Access Compliance Report

Public Rights-of-Way

(Curb Ramps)

Intersection ID: 42369	Main Street: BENTGRASS_RUN_DR	Cross Street: LYLETON_LN	Location: W
ADA ID: 291C8E8FB7AB	Ramp Type: PerpDiag	Initial Pass/Fail: Fail	Overall Compliance: No
Severity Score: 21.25			
Codes/Mitigation Info/Possible Solution		Field Measurements/Component Compliance

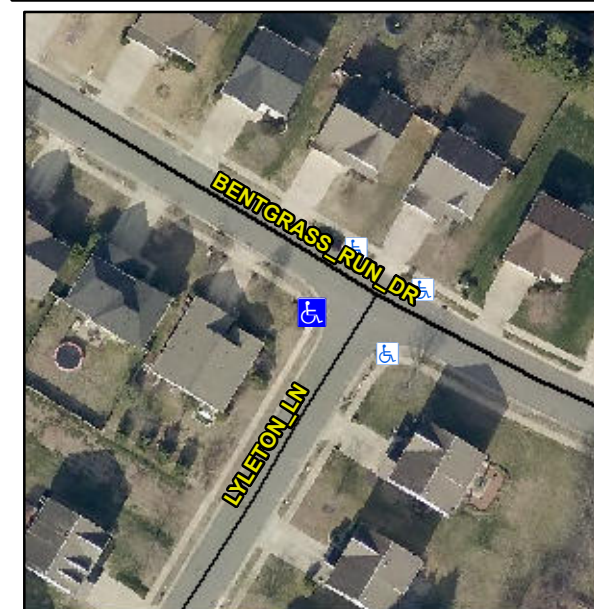
R304.5.1, R304.2.2

Compliance	Description	Data	Compliance	Description	Data
N/A	Ramp Length (in)	43.0	No	Ramp Slope (%)	11.5
No	Ramp Width (in)	46.5	Yes	Ramp XSlope (%)	1.3
N/A	Flare Type LT	N/A	N/A	Flare Type RT	N/A
N/A	Flare Slope LT (%)	N/A	N/A	Flare Slope RT (%)	N/A
N/A	Flare Traversable LT?	N/A	N/A	Flare Traversable RT?	N/A
N/A	Landing Length (in)	N/A	N/A	DWS Provided?	N/A
N/A	Landing Width (in)	N/A	N/A	DWS Contrast?	N/A
N/A	Landing Slope (%)	N/A	N/A	DWS Length (in)	N/A
N/A	Landing X Slope (%)	N/A	N/A	DWS Full Width?	N/A
N/A	Landing Curb? (Y/N)	N/A	N/A	DWS Offset (in)	N/A
N/A	Shared Landing?	N/A			
N/A	Gutter Ponding?	N/A	N/A	Gutter Slope (%)	N/A
N/A	Gutter Lip Ht (in)	N/A	N/A	Gutter X Slope (%)	N/A
N/A	Painted X Walk1?	No	N/A	Painted X Walk2?	No
	X Walk 1 Direction	To SE		X Walk 2 Direction	To NE
N/A	X Walk 1 Width (in)	N/A	N/A	X Walk 2 Width (in)	N/A
	X Walk 1 Slope (%)	0.7		X Walk 2 Slope (%)	1.4
	X Walk 1 X Slope (%)	0.9		X Walk 2 X Slope (%)	2.2

Remove & Replace Curb Ramp With Two New Directional Ramps or Equivalent.
